Re: Structural Observation — 1434 Main Street, Lillington, NC 27546

At your request, on March 18, 2021 we performed a visual structural observation of structural concerns identified by *Pillar to Post Home Inspections* in their report dated 1/12/2021 for the Lillington residence noted above. The structure is a conventionally framed, detached, single family residence with raised first floor framing over a pier/curtain wall foundation system (*see picture 1*).

Picture 14 – Failed pier

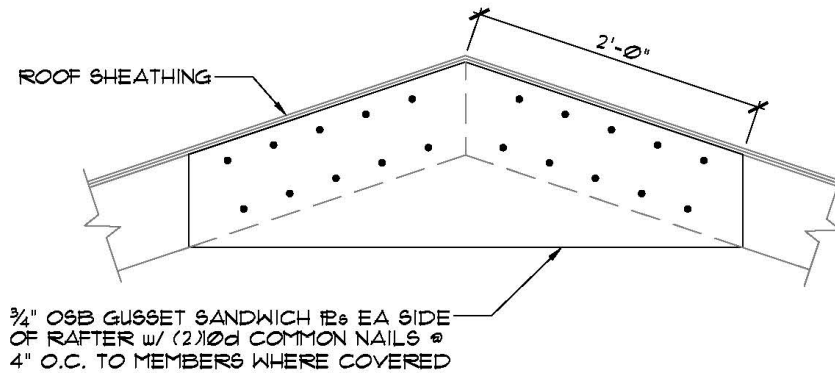
- *This pilaster should be removed and replaced with an 8"x16" CMU pilaster per the specifications above.*
- The middle pier on the girder beneath the original home was failed (*see picture 14*).

- *At the splice in the girder, install a new 8"x16" hollow CMU pier with solid 8" cap, centered over a 24"x24"x10" thick poured concrete footing set at least 12" into suitable bearing soils. The contractor should take care that the soils at the base of the footing are not undermined by the excavation that is to the right of this location.*
